RE: 130 – 150 FOREST ROAD, LARA – RESPONSE TO MATTERS RAISED BY COUNCIL

In November 2013, BMT WBM Pty Ltd (BMT WBM) prepared an Addendum 8 report (BMT WBM, 2013) that provides advice on hydrological and hydraulic matters for the proposed extension of the residential development area of Lara, south of the existing Grand Lakes Estate. This Addendum 8 Report was prepared for TGM Group Pty Ltd (TGM) on behalf of L.Bisnella Developments Pty Ltd.

The City of Greater Geelong (Council) provided a response to TGM on 26th February 2014 that sought further clarification of a number of matters presented in the Addendum 8 Report. This letter seeks to provide the clarification. The letter follows the format whereby Council's specific clarification has been reproduced in italics, with BMT WBM response following in normal text.

Figure 1 Boundary Location and Existing 100 year ARI flood extent

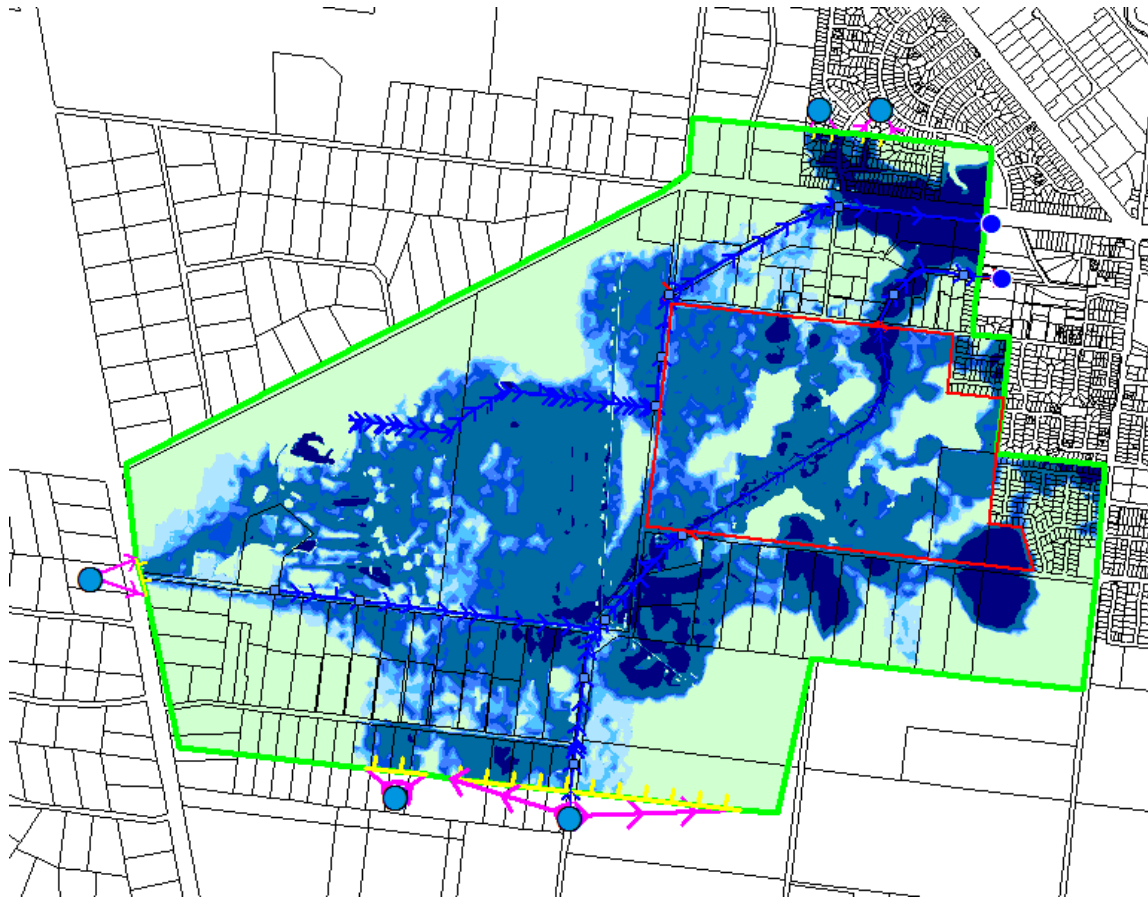
Fig 4-1 shows an external flow boundary north of the industrial area & extending nearly to Broderick Rd, but there isn't a flood extent directly downstream of the flow boundary on Fig 7-1.

TUFLOW (the adopted hydraulic modelling package) does not necessarily apply water along the full width of an inflow boundary but instead applies the flow at each time step to the flood extent determined in accordance with the local hydraulic conditions. To further explain, at the start of the simulation the inflow is applied at the lowest point along the boundary line, and then as the flow increases, the subsequent flood height and flood extent increases along the boundary line. As shown in Figure 1, there is floodwater located immediately downstream of both the southern external inflow boundaries (located north of the industrial estate), although not along their full widths.
